PRFUP20220879
Approved change as of
01/23/2023

SCOPE CHANGE OMITTED FROM WORK - (568323-155072) & (568322-155085)

PUGET SOUND ENERGY	ENGR1 LUMEN TK#5044288		INCIDENT N/A	MAOP N/A
	RPLC (10) POLES, EXT. SEC RISER, ZIPTIE SEC, WRKOUT SEC.		Gas Order N/A	Elect Order 18606193
	711 W MAIN PUYALLUP, WA 98371		SCALE AS NOTED	PAGE 1/1
DESIGNED BY POTELEC

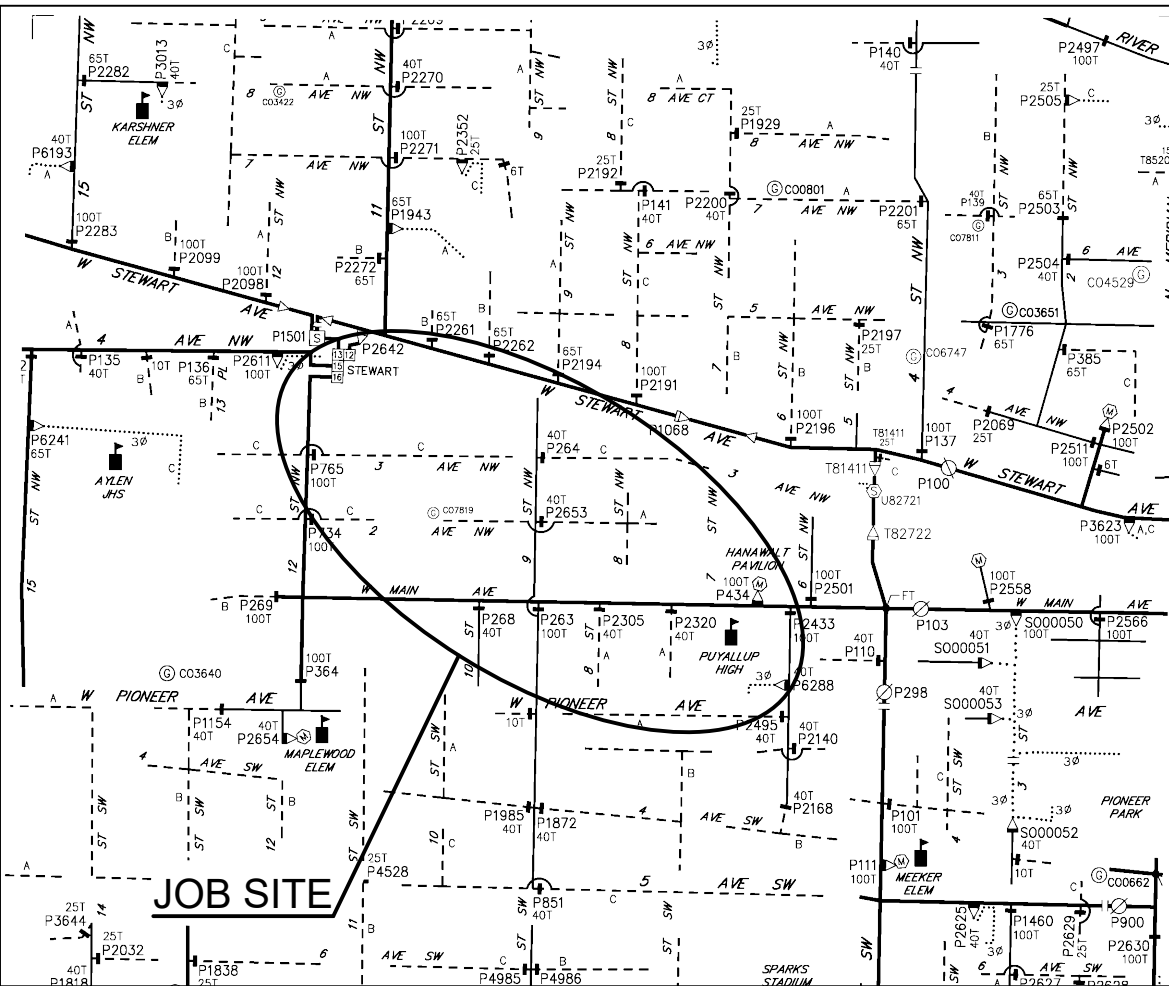
- P05 (568323-155054)
- REPLACE EXIST 40' POLE
 - INST NEW 45' CL1 POLE (6010.1000 PD451)
 - INST 1Ø SGL PTP (6031.1010 TAN112)
 - TRANSFER EXIST OH SEC
 - TOP POLE TO COMMS
- P06 (568322-155116) SCOPE CHANGE - WAS P08
- REPLACE EXIST 40' POLE
 - INST NEW 45' CL1 POLE (6010.1000 PD451)
 - INST 1Ø SGL PTP (6031.1010 TAN112)
 - TRANSFER EXIST 25kVA 120/240v XF W/ LB C/O FUSED AT 10T (342200)
 - TRANSFER EXIST OH SEC
 - TOP POLE TO COMMS

- P07 (568321-155129) SCOPE CHANGE - WAS P09
- REPLACE EXIST 40' POLE
 - INST NEW 45' CL3 POLE (6010.1000 PD453)
 - INST 1Ø SGL PTP (6031.1010 TAN112)
 - TRANSFER EXIST OH SEC
 - TOP POLE TO COMMS

- P08 (568321-155144) SCOPE CHANGE WAS P10
- REPLACE EXIST 45' POLE
 - INST NEW 50' CL2 POLE (6010.1000 PD502)
 - INST NEW 3Ø SGL ARM (6033.1010 TAN312)
 - INST 1Ø SGL PIN FG ARM (6031.2010 TANF152)
 - INST COVERED CU JUMPER
 - INST NEW 1Ø LB C/O (6022.1000 DLS115L) FUSED AT 40T (3412500)
 - INST EXIST SWITCH #P2653
 - INST NEW 25kVA 120/240v XF W/ LB C/O FUSED AT 10 (3412200)
 - RECONNECT EXIST SERVICES TO NEW XF
 - WRECKOUT OWS APPROX. 100' (_____) TO P09
 - TRANSFER EXIST OH SEC
 - TRANSFER EXIST S/L (SLAP4307)
 - TOP POLE TO COMMS

- P10 (568318-155228) WAS P11
- REPLACE EXIST 40' POLE
 - INST NEW 45' CL2 POLE (6010.1000 PD452)
 - TRANSFER EXIST OH SEC
 - TRANSFER EXIST S/L (SLAP4246)
 - INST 3/8" SIDEWALK GUY (6013.0180 GYD3PB) ATTACH TO EXIST ANCHOR
 - TOP POLE TO COMMS

- P11 (568286-155175) WAS P12
- REPLACE EXIST 40' POLE
 - INST NEW 45' CL1 POLE (6010.1000 PD402)
 - TRANSFER EXIST OH SPAN GUY
 - INST 7/16" SIDEWALK GUY (6013.0180 GYD7PB) ATTACH TO EXIST ANCHOR
 - TOP POLE TO COMMS

- P12 (568283-155209) WAS P13
- WRECK OUT EXIST 1/0 OH TPX APPROX. 100' (_____) TO P13

- P14 (568285-155208) WAS P15
- REPLACE EXIST 30' POLE
 - INST NEW 35' CL2 POLE (6010.1000 PD352)
 - RAISE EXIST STREET LIGHT ARM APPROX 12"-18" (_____) ABOVE TOP COMMS
 - ADD S/L MOLDING GRND WIRE (8920300)
 - EXTEND EXIST 2" RISER APPROX. 1' (_____) OR AS MUCH AS POSSIBLE
 - SPLICE ON TOP OF RISER 1/0 UG APPROX. 5' (_____) IF NECESSARY
 - TRANSFER OH SEC
 - TOP POLE TO COMMS

- P15 (568273-155175) WAS P16
- REPLACE EXIST 40' POLE
 - INST NEW 45' CL2 POLE (6010.1000 PD452)
 - INST 1Ø SGL PTP (6031.1010 TAN112)
 - INST NEW 13x24 SEC FG HH. SEE HH01 NOTES
 - TRANSFER EXIST OH SEC
 - TOP POLE TO COMMS

- P16 (568260-155174) WAS P17
- REPLACE EXIST 40' POLE
 - INST NEW 45' CL1 POLE (6010.1000 PD451)
 - INST 1Ø SGL PTP (6031.1010 TAN112)
 - TRANSFER EXIST 25kVA 120/240v XF W/ LB C/O FUSED AT 10T (342200)
 - TRANSFER EXIST OH SEC
 - TRANSFER EXIST S/L (SLAP4209)
 - TOP POLE TO COMMS

Pole 14 will be replaced under this submittal
